# HRI, Inc.

RE: Additional costs associated with operation of Town of Crownpoint water wells due to HRI's *in situ* mining operations.

#### **Q3/95 Comment: Effect of Groundwater Drawdown on Town of Crownpoint Wells**

**50. Degradation of Crownpoint Water Supply Wells By Restored Solution Mine Ground Water**

**Figure 50-1**

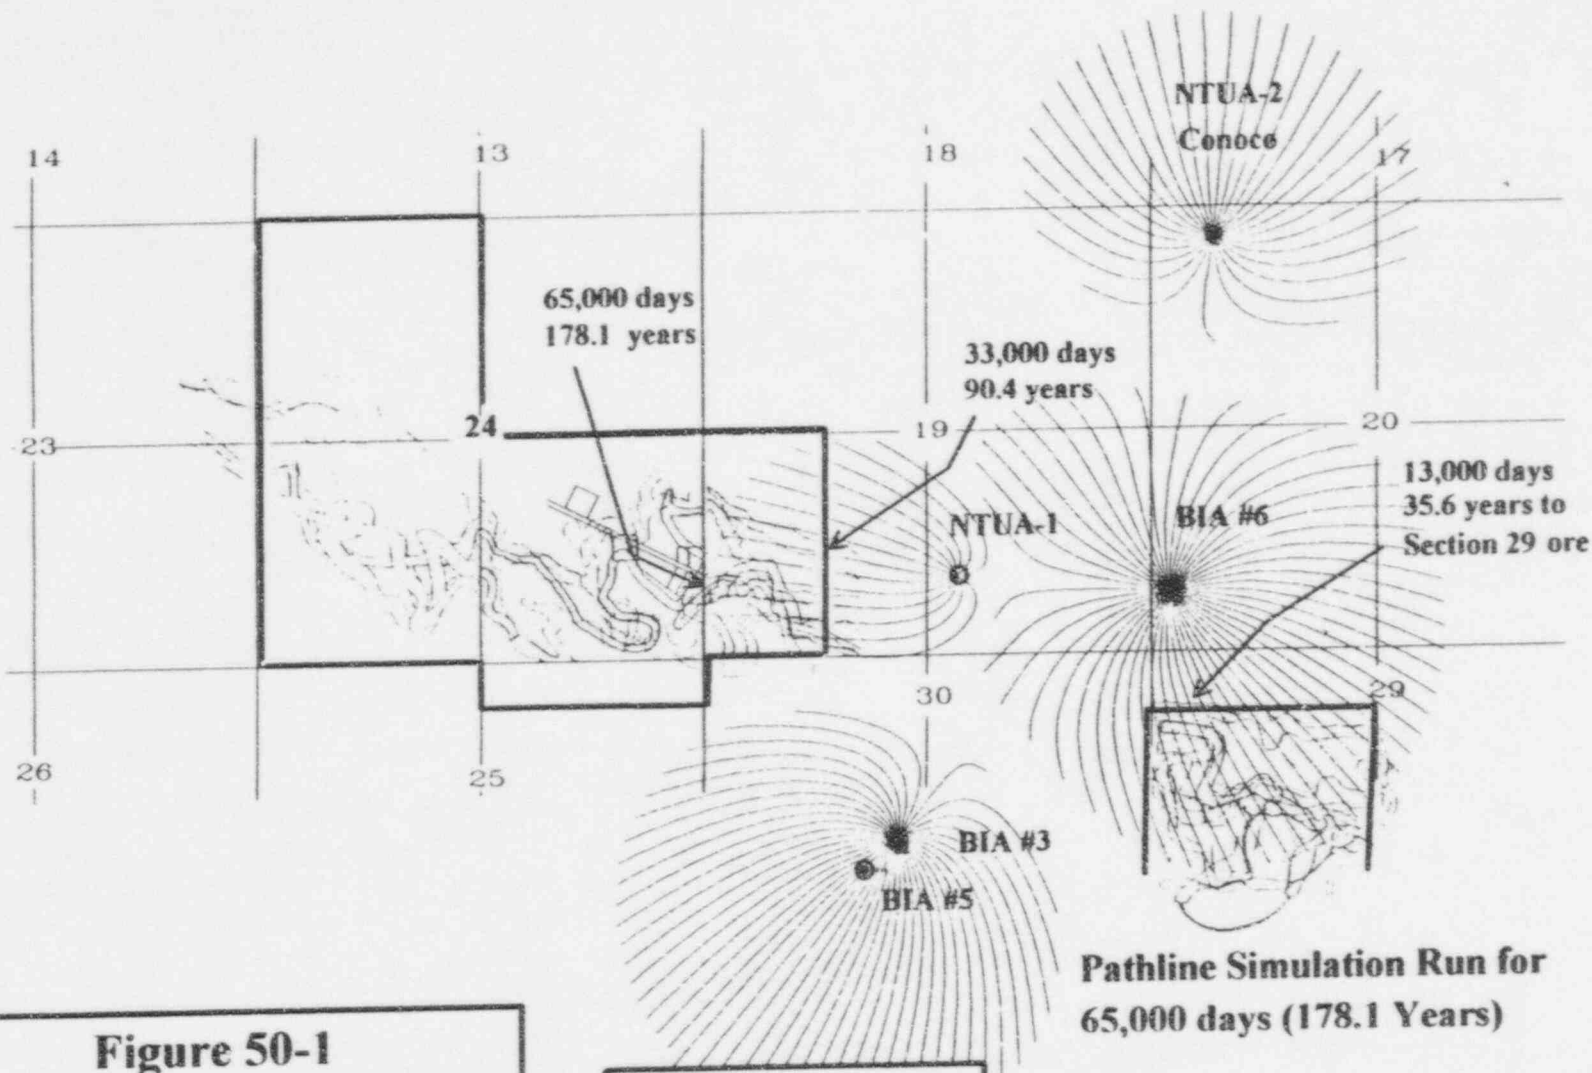
**Discussion** - Given the location of the license boundaries, ground water degraded by solution mining activities, even after restoration, might degrade the town of Crownpoint water supply. Mining in the Crownpoint mine units would occur on minerals operating leases in Section 24, extending eastward into Sections 19 and 29, T17N R12W (Reference 1, page 1-3). Pumping from the town of Crownpoint water supply wells causes ground water under the Crownpoint mine units to flow towards the water supply wells in Crownpoint (Reference 1, page 3-12). The town of Crownpoint is supplied by 5 wells BIA-5, BIA-3, BIA-6, NTUA-1, and NTUA-2. All of these wells pump water from the West Water Canyon Member. Two of the wells, NTUA-2 and BIA-5, are located no more than 2,640 ft. (1/2 mile) outside the licensed boundary. Well BIA-3 is located approximately 1,760 ft. outside the licensed boundary. Well BIA-6 is located just outside the boundary, and well NTUA-1 is located inside the boundary (Reference 2, Figure 2.3-1, page 27). The Crownpoint site is located so close to the town of Crownpoint, that pumping from the town wells causes the water levels under the Crownpoint site to move up and down (Reference 2, pages 47-54). The Crownpoint site is located on three sides of the town of Crownpoint (north, east, and west) (Reference 1, page #1-5). This means that water moving into the wells from the north, east, and west will be processed by solution mining activities and then could move a relatively short distance to the town of Crownpoint water supply wells.

**Action Needed:** Demonstrate that ground water degraded by solution mining activities, even after restoration for both of the UNIT 1 and the Crownpoint properties will not degrade the town of Crownpoint water supply (mining over the whole of both properties should be considered, not just the first 5 years at the Crownpoint property).

As stated under the previous heading, the degree of water level change is not reflective of the rate of water level movement. Table 50-1 illustrates the travel time for water to move from the closest license area boundary from Crownpoint and UNIT 1, and individual water wells, under worst-case conditions. Worst-case conditions assume all mine bleed stops, pumping of existing water supply wells continues at present rates, and water is allowed to migrate in the subsurface without any corrective action taken. Given these circumstances, water will require 35.6 years to migrate from the closest Crownpoint license boundary to the closest well (BLA 6) and 1,657.5 years to migrate from the closest UNIT 1 boundary to NTUA 1. For the purpose of this illustration, the NW/4 of Section 24 is presumed to be part of the Crownpoint Property. Models illustrating these migration rates are within Attachments 50-1 and 50-2.

### Figure 50-3

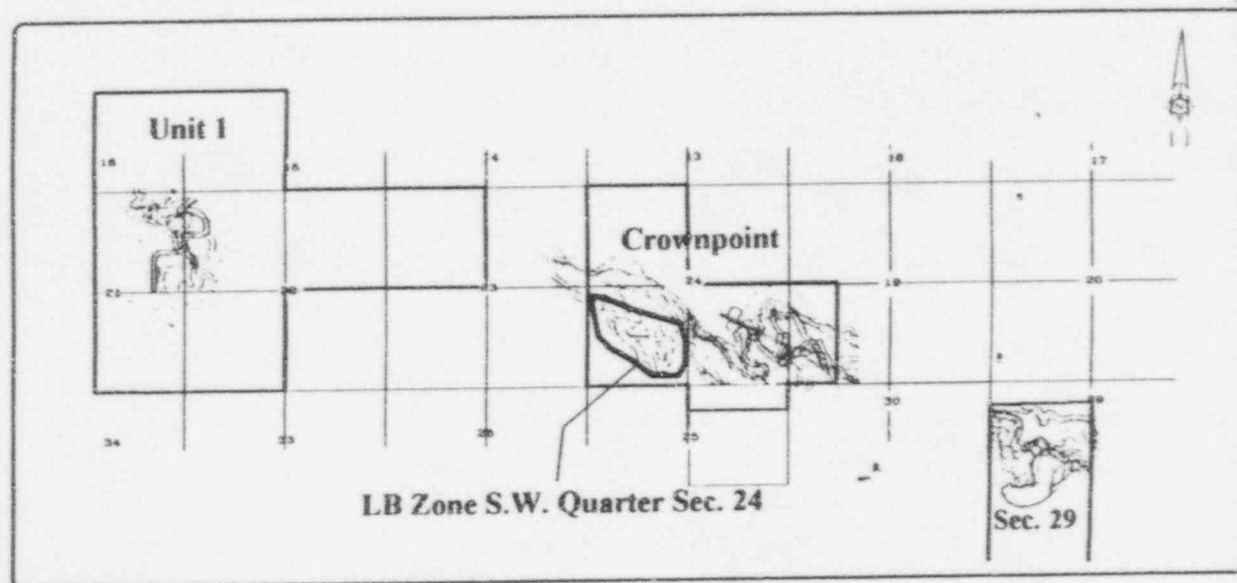
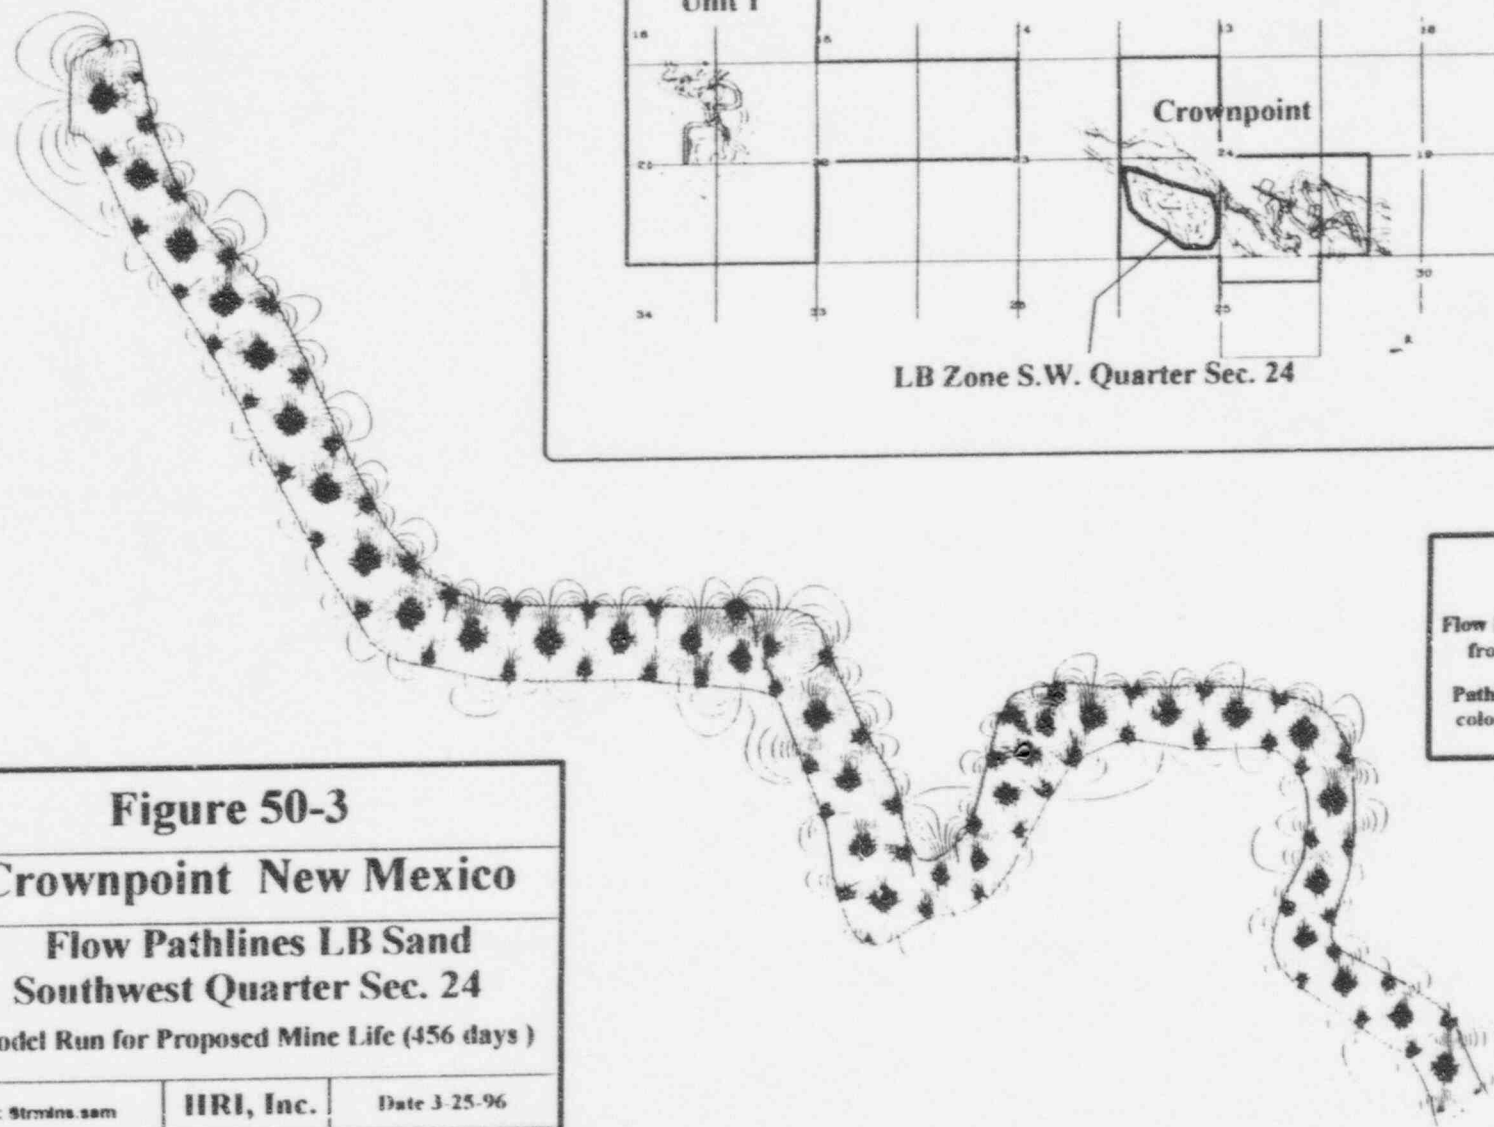
Few *in-situ* mines restore the ground water to baseline conditions. Most successful restorations are to the water use or average water quality standards. Furthermore, the approach used to determine a successful restoration has varied from mine site to mine site. At commercial *in-situ* mining sites, small volumes of water are sampled (either from wells or plant pipes and tanks) to determine when restoration parameters have been achieved. At best these are statistically based conclusions, which cannot guarantee that some contaminated ground water has not been left in the ground. However, most *in-situ* mines are in remote locations. This means that if some water has not been restored, there is significant time and distance for the water to reequilibrate to its natural water quality before it reaches a public water supply. However, at the Crownpoint site, this buffer of time and distance may not exist and therefore, it is possible that after restoration, contaminated ground water might reach the town water wells.

The efficiency of ground water sweep between injection and production wells can be and is modeled before a wellfield is installed. This is performed by streamline modeling. An example of streamline modeling of an individual ore zone for the Crownpoint project is shown in Attachment 50-4. Here we see that while individual wells cover a statistically small area, the radial flow of the injection and extraction fluid swept the entire orebody. It matters not whether the operations are conducted during the restoration or production phases, the reservoir engineering principle associated with wellfield design are the same.

**ATTACHMENT 60-1**

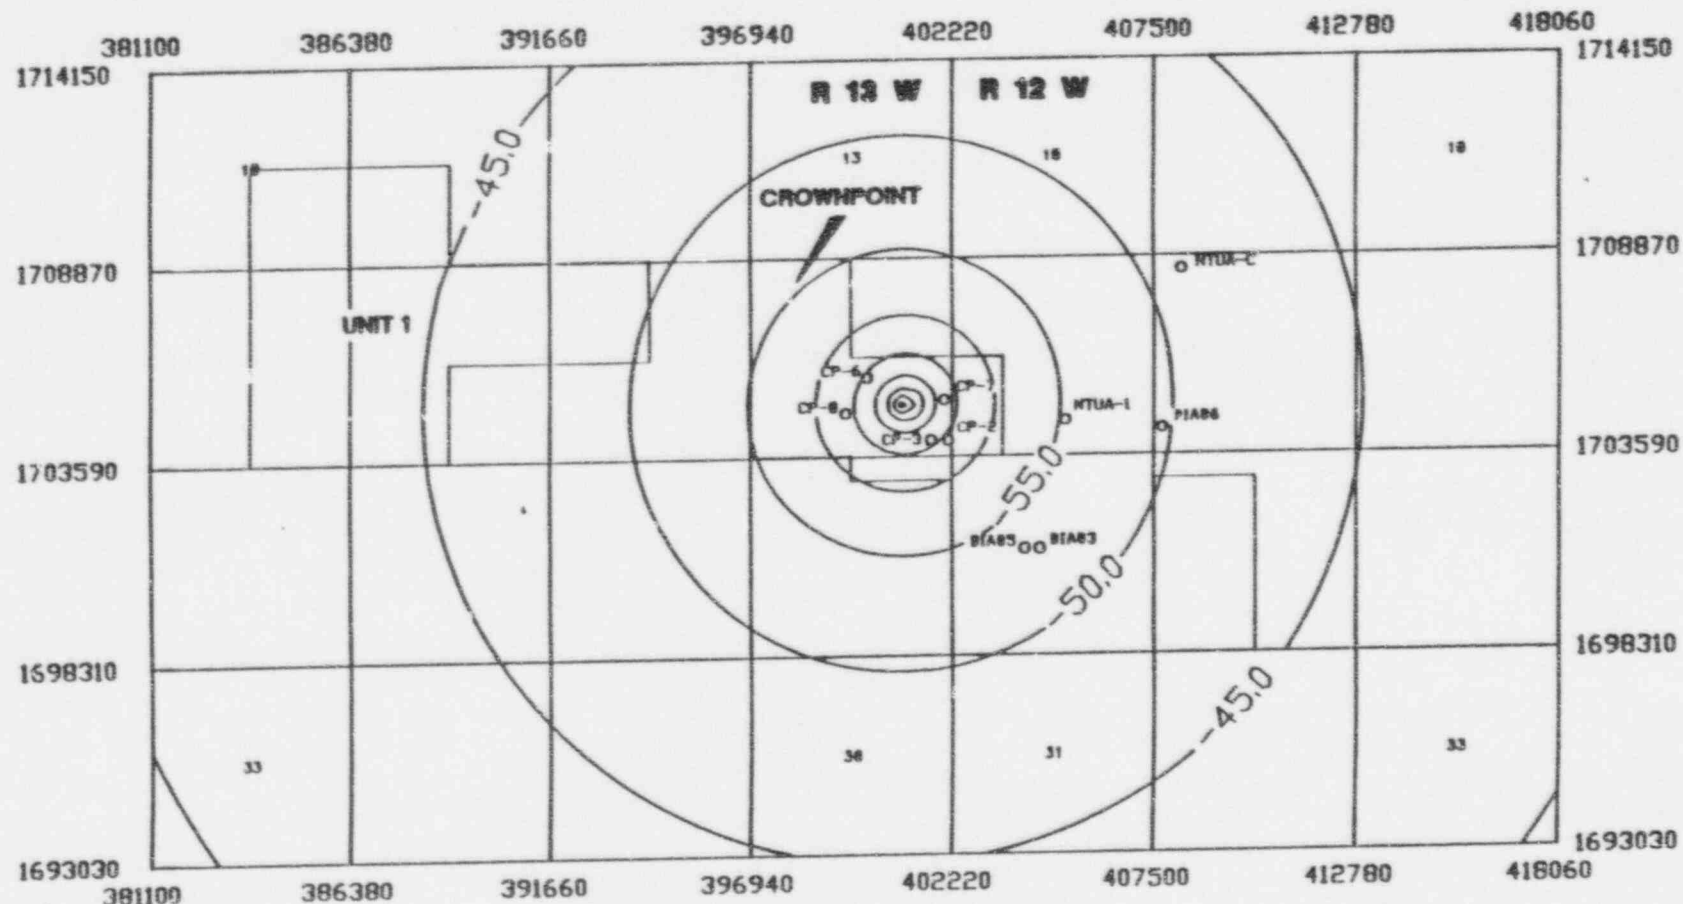
**Discussion** - The application (Reference 3) contains a calculation of drawdown effects for the Churchrock property over its predicted 8 years of operation. However, the application does not contain a calculation of drawdown effects for the Crownpoint property for its full 20 years of operation and does not contain one for the UNIT 1 property at all.

**Action Needed:** The maximum drawdown effects over the life of the operation need to be calculated for each of the three sites. In addition the maximum drawdown effects on the Crownpoint public water supply wells due to the combined groundwater withdrawals of the UNIT 1 and Crownpoint properties should be calculated for the life of the project.

In order to provide additional backup regarding the final drawdown effects caused by mining, a longer-term mine plan that includes both Crownpoint and Unit 1 was developed. This plan was conservatively developed to use the maximum amount of ground water removal for the 21 year period. Attachment 60-3 is a bar chart showing the mining plan. This plan was modeled with Aquasim to determine the maximum drawdown effect at the end of the plan. The transmissivity and storativity used in the model were 2,550 and 0.000086, respectively as used in the previous modeling. The cumulative drawdown after 21 years is shown on Attachment 60-1. Drawdown at the Crownpoint water wells ranges from 45 to 55 feet, with the maximum drawdown at a water well of approximately 55 feet at well NTUA-1. During the mining, the maximum ground water withdrawal and drawdown would occur after 17 years. Attachment 60-2 is a map showing the total drawdown at that time.
